CITY OF PACIFIC GROVE
300 Forest Avenue, Pacific Grove, California 93950

AGENDA REPORT

SUBJECT: Consideration of Architectural Design Change 16-173 to allow changes to Architectural and Use Permit 16-056 regarding the relocation of an in-ground hot tub.

ADDRESS: 1209 Surf Ave.

SITE PLAN

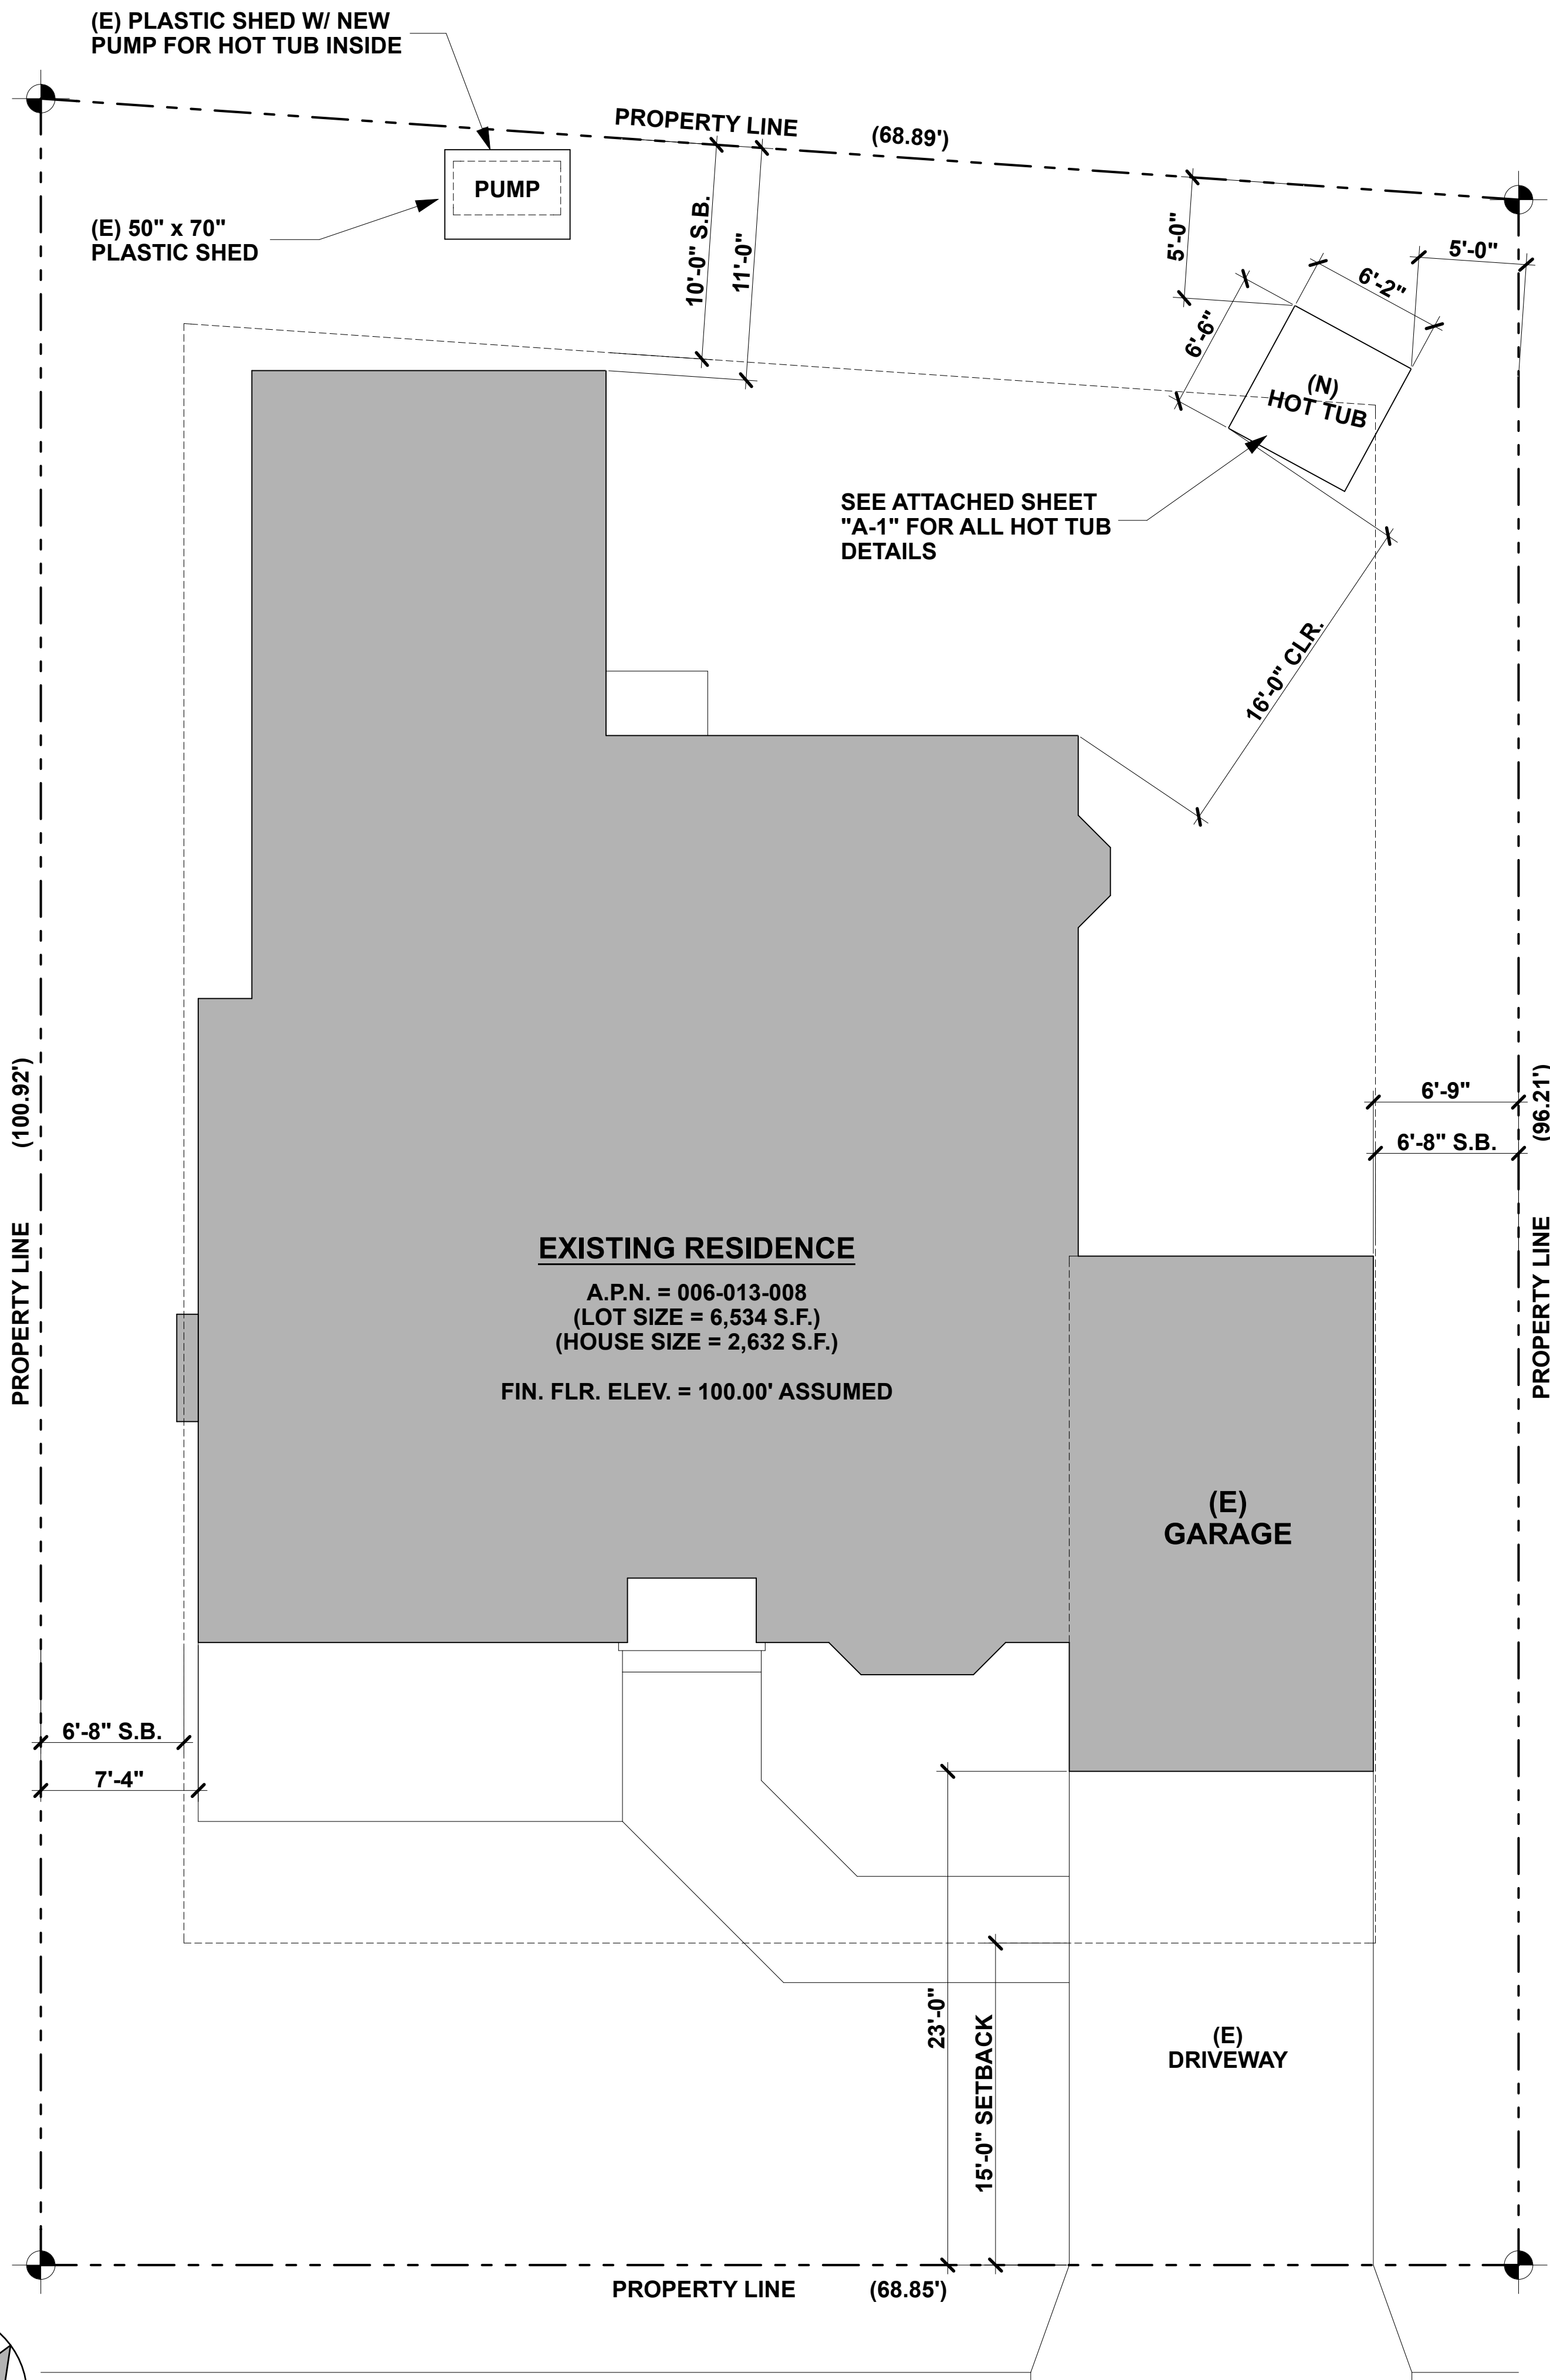
On March 2, 2016, property owner Matt Clark applied for an Architectural Design Change Permit to relocate the hot tub to approximately 5 feet from the rear yard property boundary, and 5 feet from the side yard property boundary. The permit, Architectural Design Change 16-173, was approved by Director of Community and Economic Development Department Director Mark Brodeur on March 7, 2016. On March 16, 2016, the City of Pacific Grove received a request for a hearing from a neighbor.

To allow design changes to Architectural Permit (AP) 16-056 for an in-ground hot tub to be located 5 feet from the side yard property boundary, and 6 feet from the rear yard property boundary.
